ADDENDUM NO. 3

Project: American Legion Core Academic Renovation

**AMERICAN LEGION HIGH SCHOOL
CORE ACADEMIC AND CAMPUS RENOVATION
SACRAMENTO CITY UNIFIED SCHOOL DISTRICT
DSA App # 02-116158; DSA File # 34-H7**

ADDENDUM # 3 – REBID
July 25, 2018

Title: UTILITY PLAN		Ref: C3.1	
Project: AMERICAN LEGION HIGH SCHOOL CORE ACADEMIC AND CAMPUS RENOVATION 3801 BROADWAY SACRAMENTO, CA 95817		Job No: -	Sheet No. ADD-3R C3.1B
		Scale: AS SHOWN	
		Date: 7-23-18

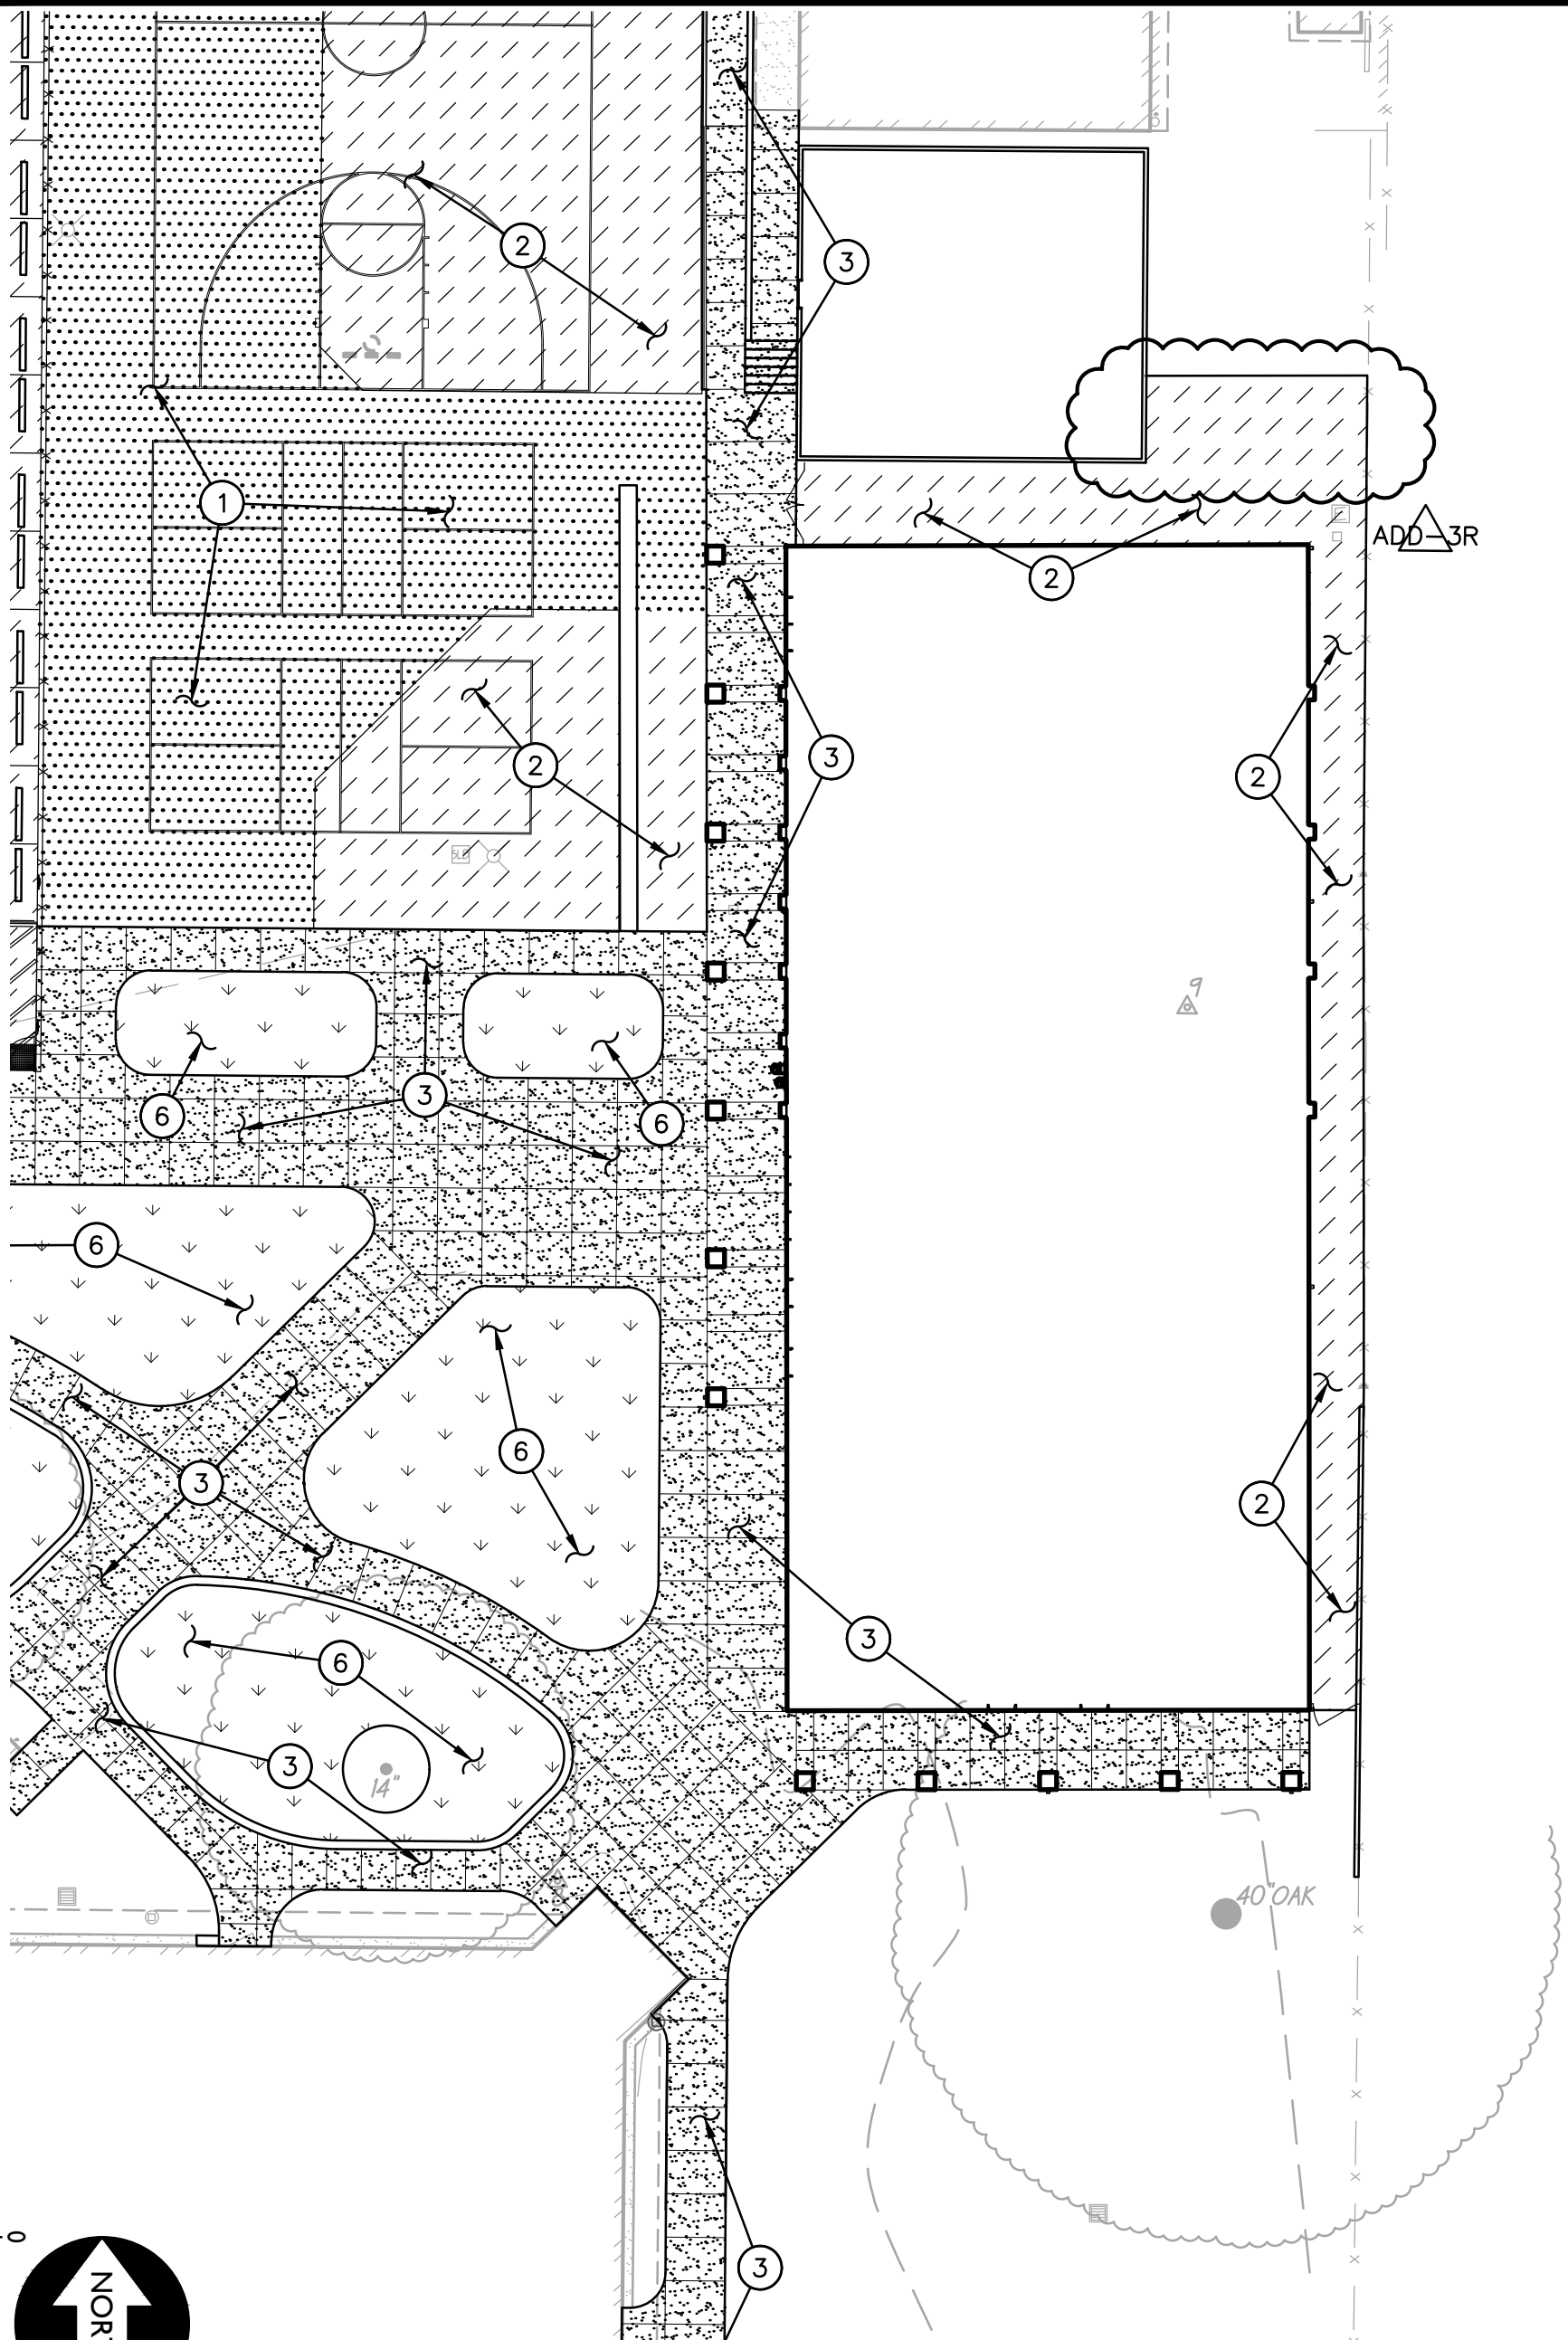
ITEM # 3R.11 Sheet ADD-2R C3.1 – Utility Plan: Update this Sheet as shown on the attached **ADD-3R C3.1A** and **ADD-3R C3.1B**. All changes have been clouded.

- 43. PLACE 4" SEWER, SLOPE VARIES, 0.020 MIN. 6
C6.1
- 44. CONNECT TO EXISTING SEWER STUB. POTHOLE AND FIELD VERIFY DEPTH AND CONDITION OF EXISTING STUB PRIOR TO ANY ON SITE TRENCHING. IF CONFLICT IS DISCOVERED NOTIFY ARCHITECT BEFORE PROCEEDING.
- 45. FOR CONTINUATION REFER TO PLUMBING PLANS. COORDINATE DEPTH AND LOCATION PRIOR TO TRENCHING.

- 52. PLACE 2" WATER LINE PER 9
C6.1
- 54. PROVIDE GATE VALVE SIZE TO MATCH LINE SIZE.
- 57. CONNECT TO BUILDING WATER SERVICE. COORDINATE DEPTH AND LOCATION OF CONNECTION WITH PLUMBING PLANS PRIOR TO TRENCHING.

C4.1A

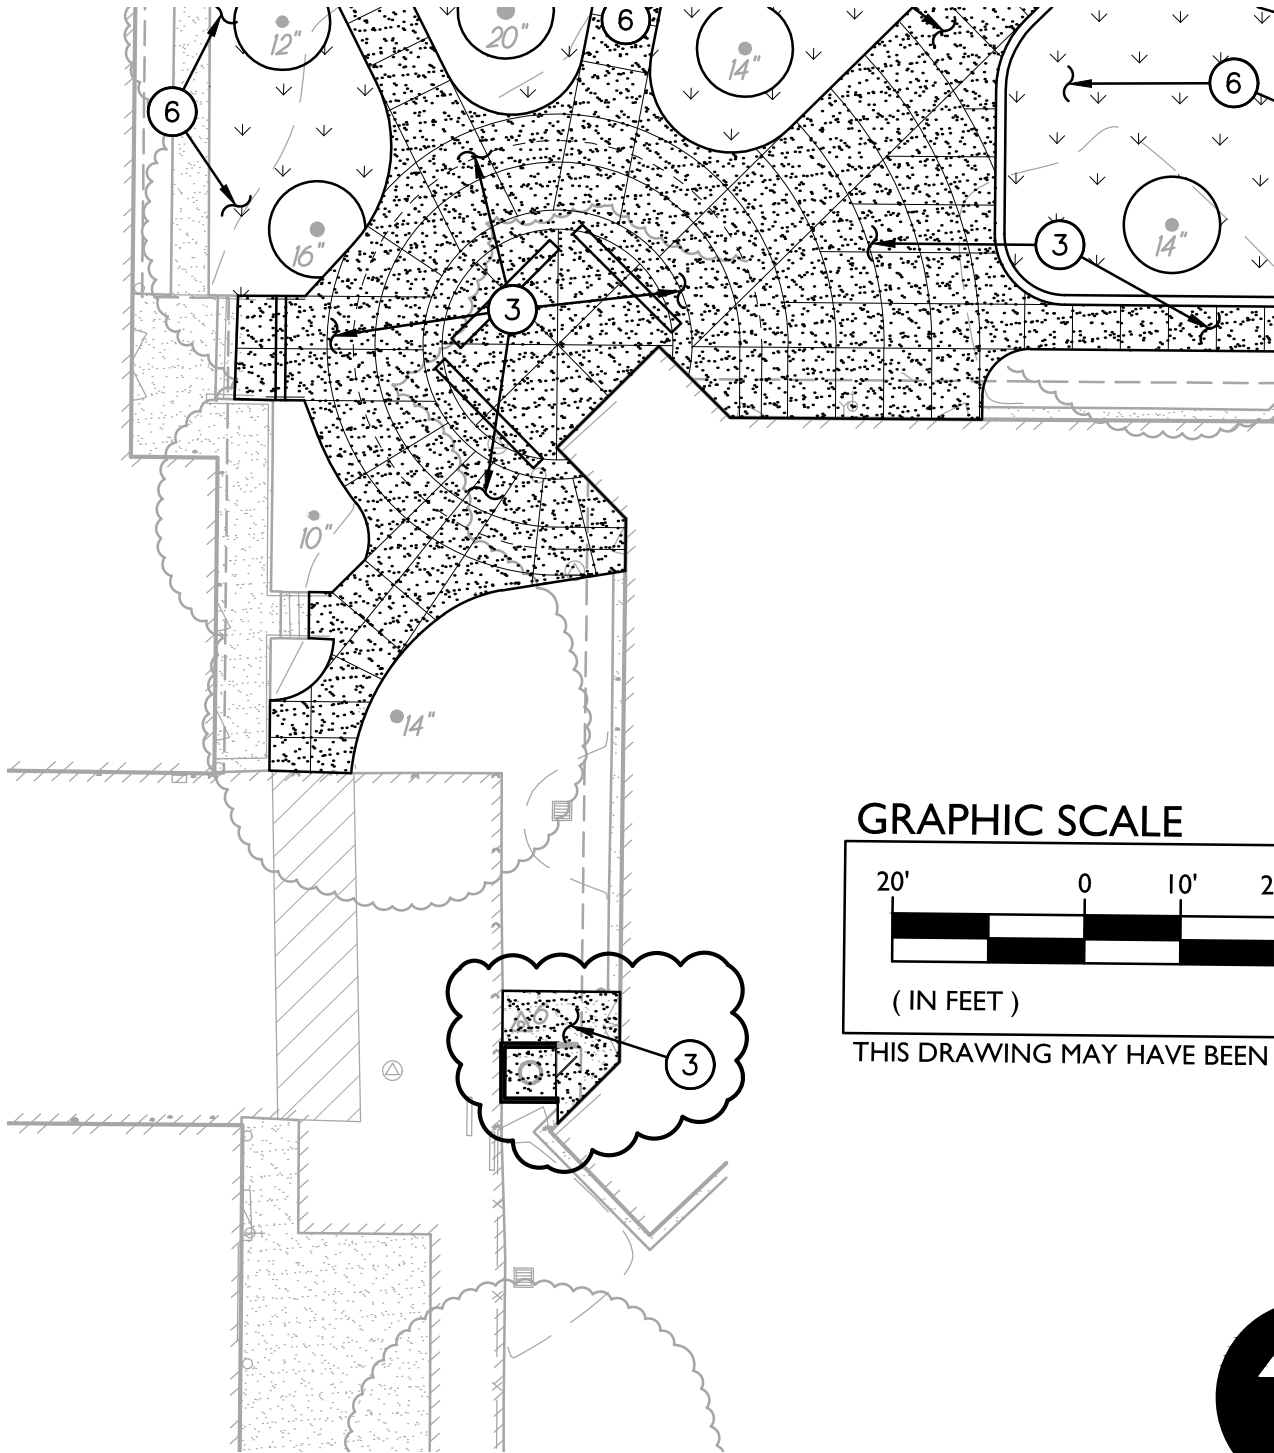
ITEM # 3R.12 Sheet ADD-2R C4.1 – Paving Plan: Update this Sheet as shown on the attached **ADD-3R C4.1A** and **ADD-3R C4.1B**. All changes have been clouded.

Title:	DEMOLITION PLAN		Ref:	C6.2
Project:	AMERICAN LEGION HIGH SCHOOL	CORE ACADEMIC AND CAMPUS RENOVATION	Job No:	-
	3801 BROADWAY SACRAMENTO, CA 95817 SACRAMENTO COUNTY		Scale:	AS SHOWN
			Date:	7-17-18
			Sheet No.:	ADD-3R 6/C6.2

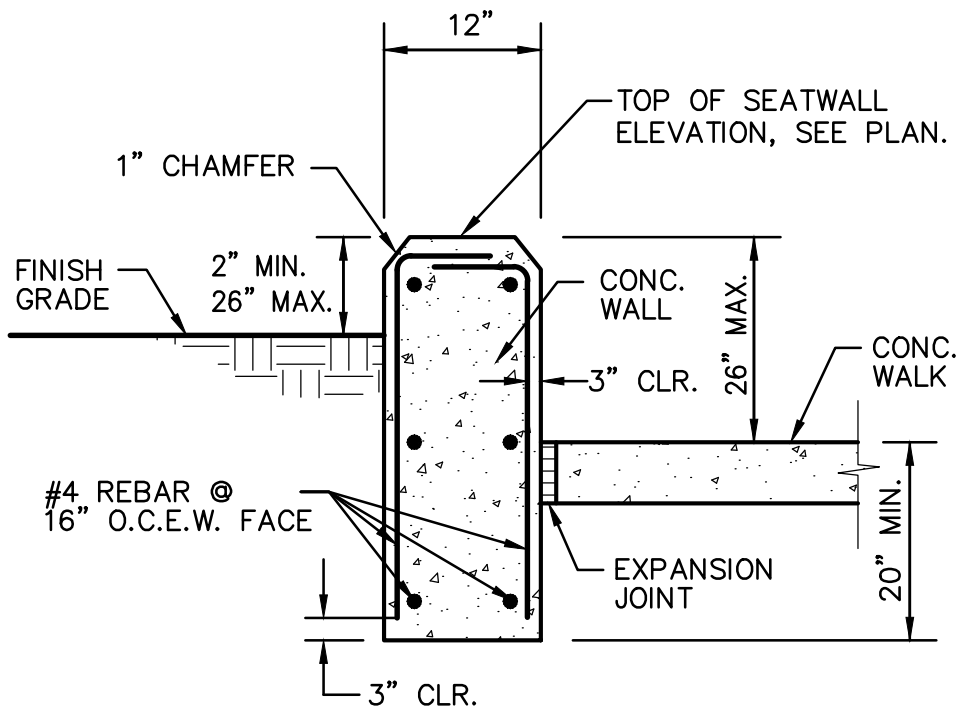
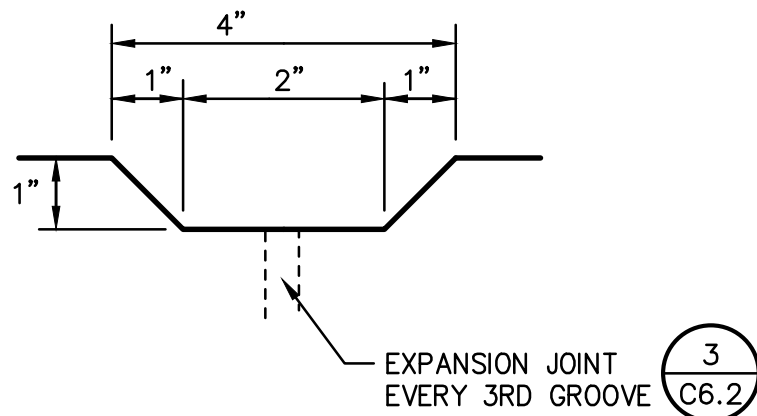
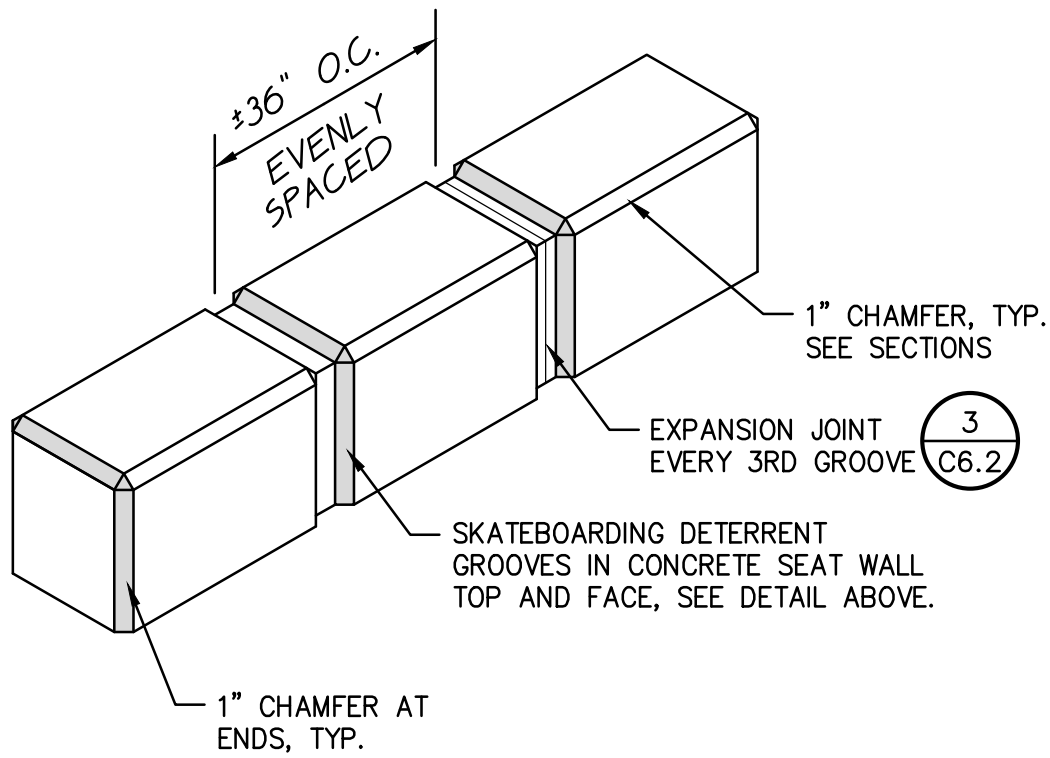
ITEM # 3R.13 Sheet C6.2 – Details; Detail 6 – Seat Wall: Replace this Detail with the attached Detail **ADD-3R 6/C6.2**.

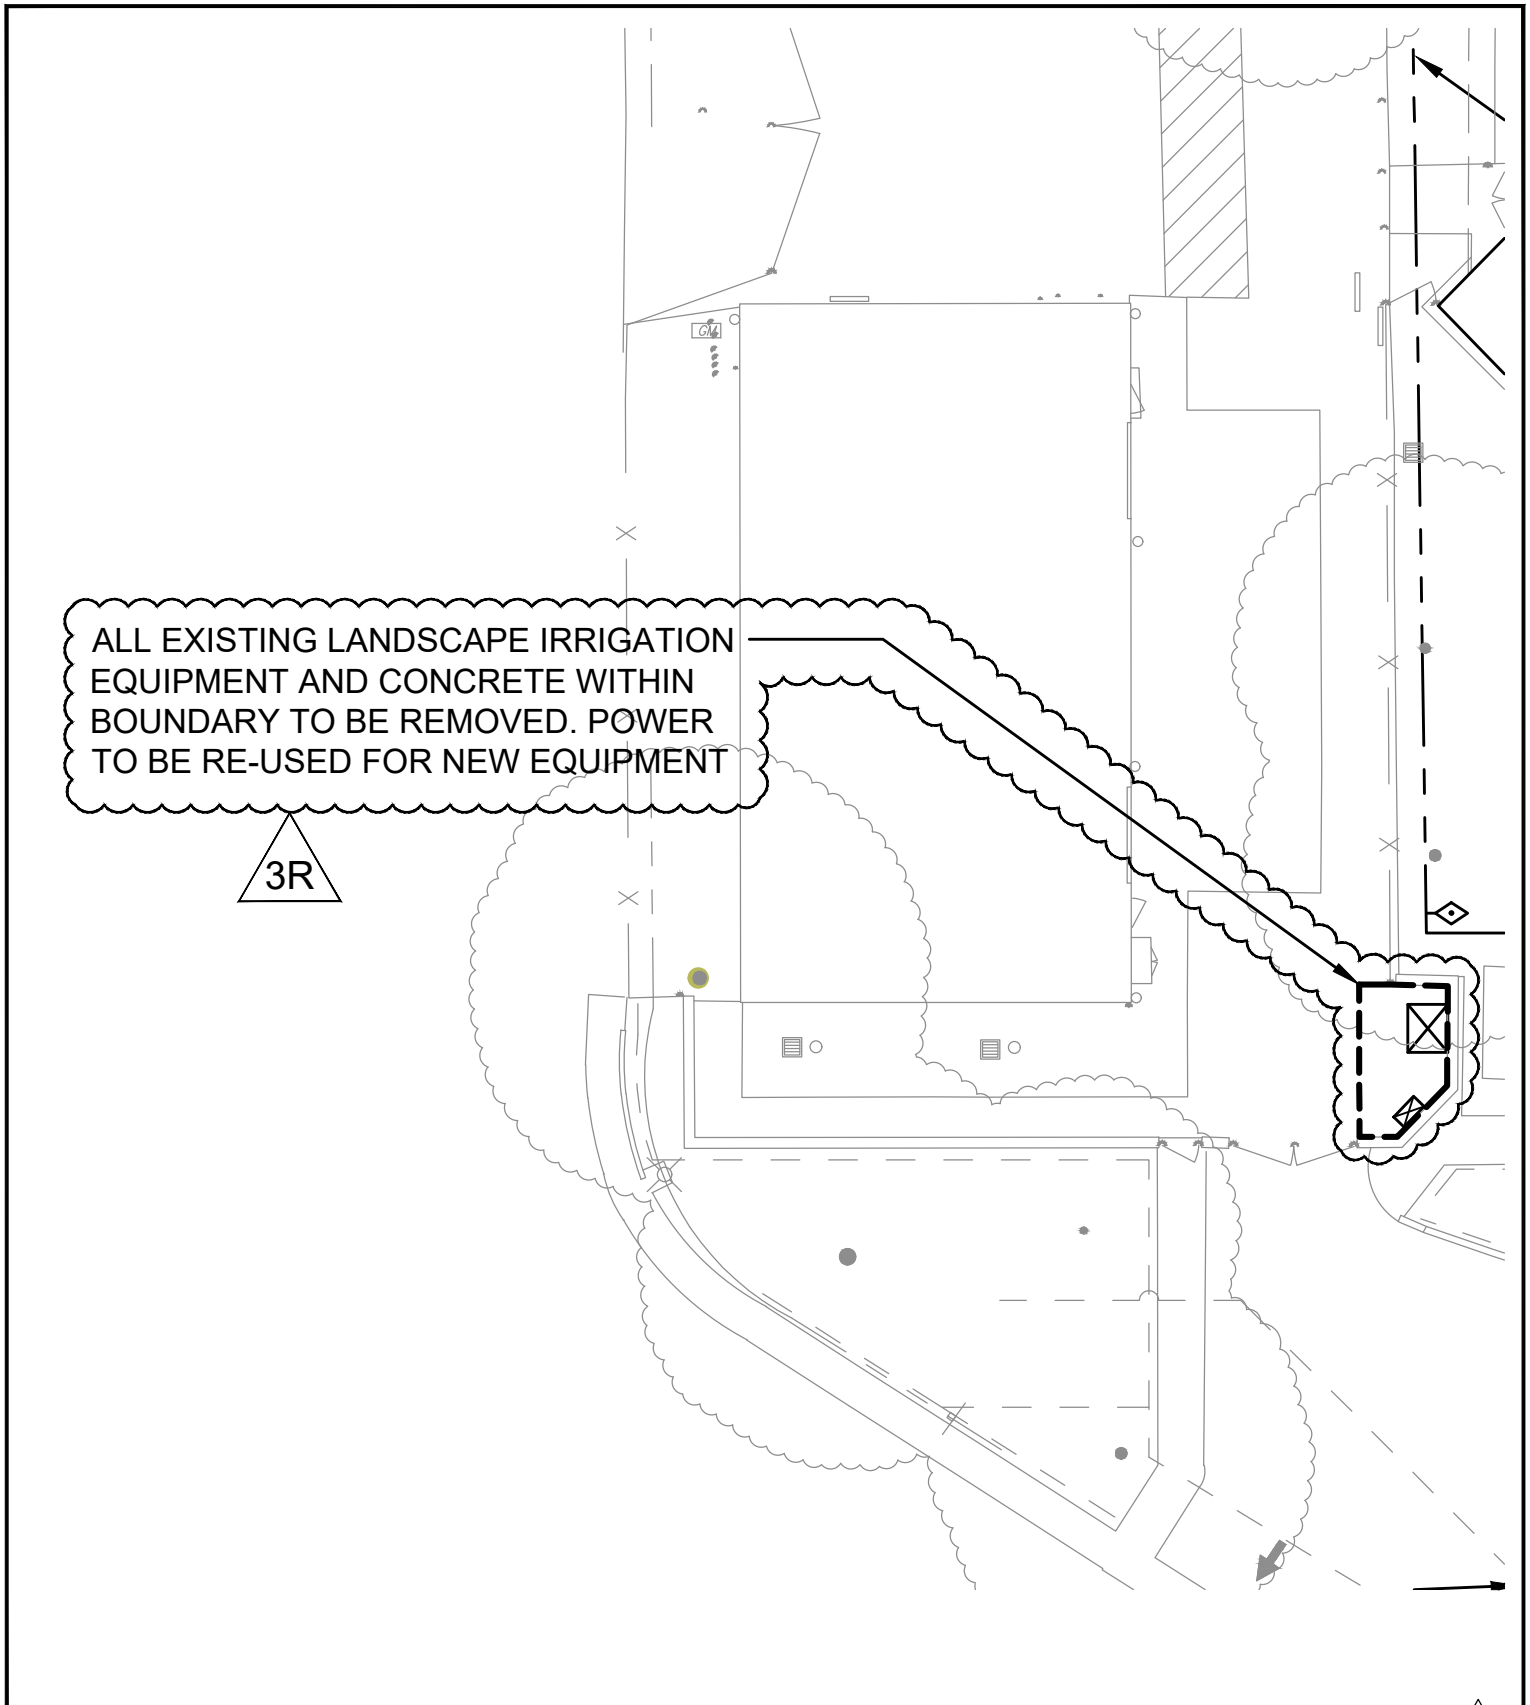
ITEM # 3R.14 Sheet L0.2 – Irrigation Demolition Plan: Update this Sheet as shown on the attached **ADD-3R L0.2A**. All changes have been clouded.

ALL EXISTING LANDSCAPE IRRIGATION EQUIPMENT AND CONCRETE WITHIN BOUNDARY TO BE REMOVED. POWER TO BE RE-USED FOR NEW EQUIPMENT
